HISTORIC PRESERVATION COMMISSION

REPORT

Case Name: Parker Townhouse Driveway Replacement

Case Number: 7-HP-2019

ATTACHMENT #3

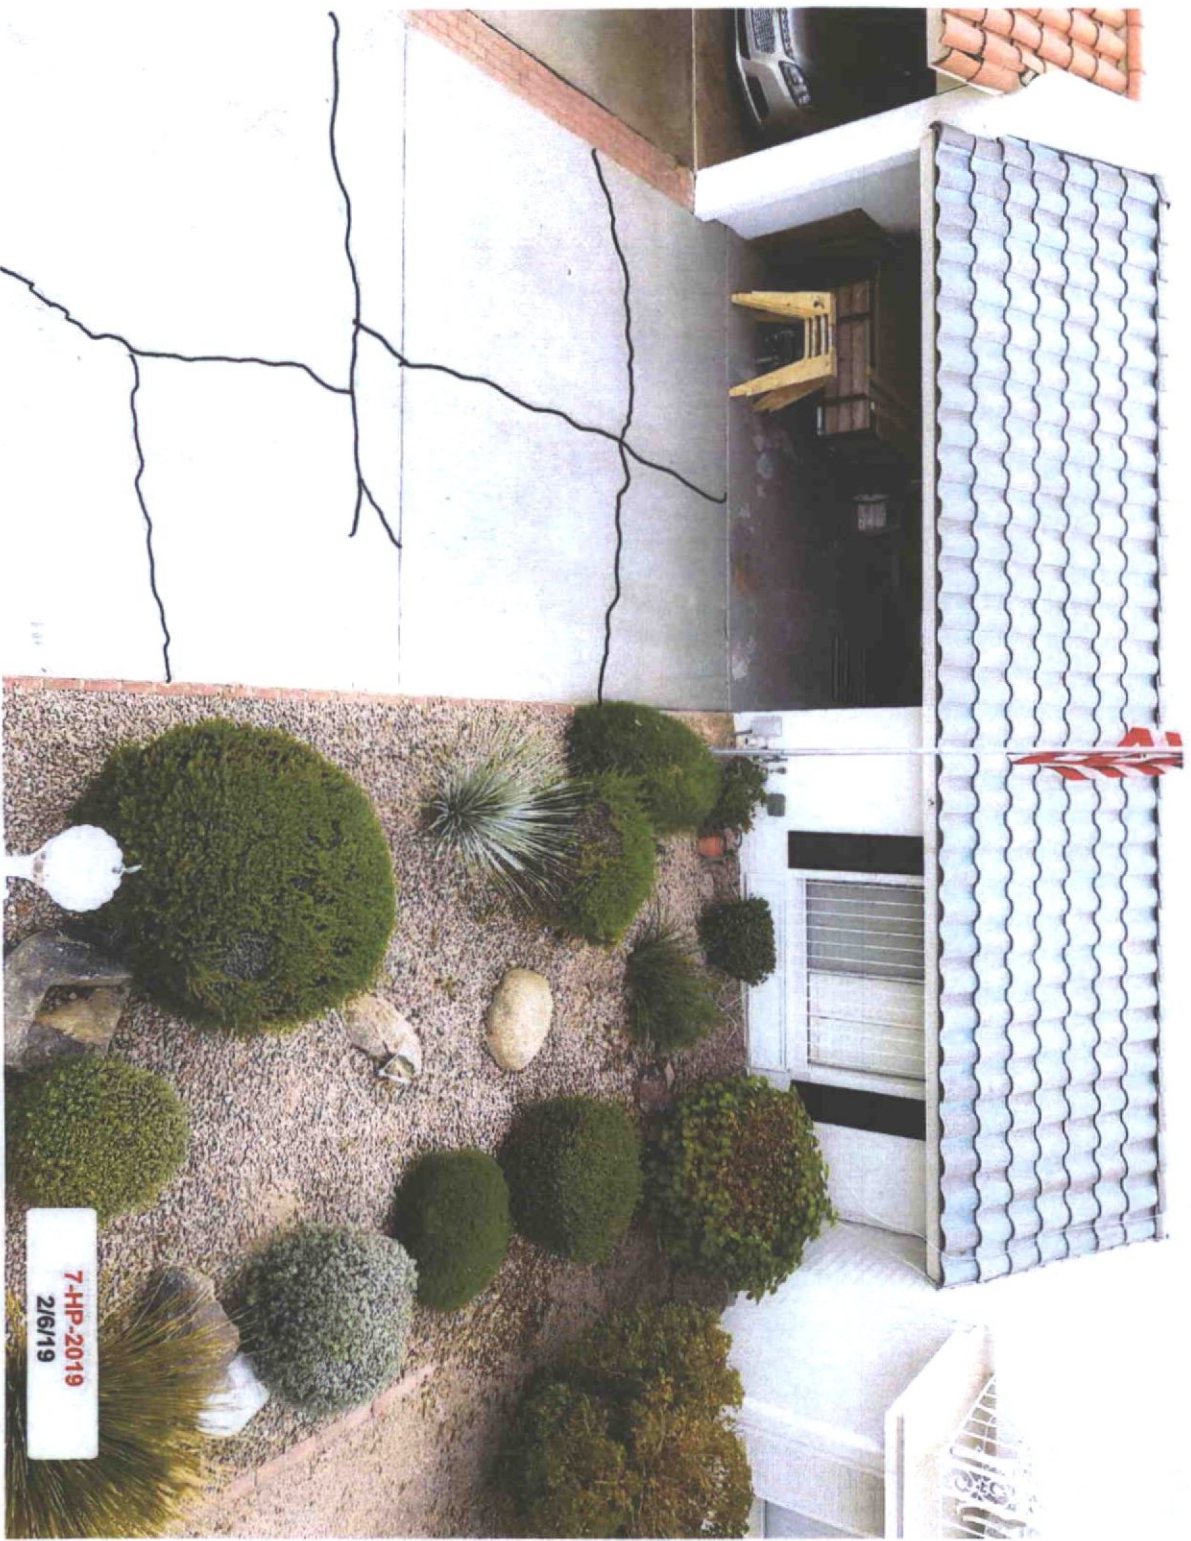
The applicant does not propose the addition of a parking bay. The applicant is proposing providing concrete pavers to replace the existing concrete slab driveway. The applicant proposes using a dark-gray and light-gray woven paver pattern for the driveway improvements (Reference Attachment #6).

Staff report includes recommended stipulations that may be applied to the request if the Historic Preservation Commission votes to approve the replacement of the concrete driveway with concrete pavers. The stipulations include using the use of only one color of paver (the lighter grey paver), and a stacked linear pattern - no angled or cross pattern (Reference Attachment #8).
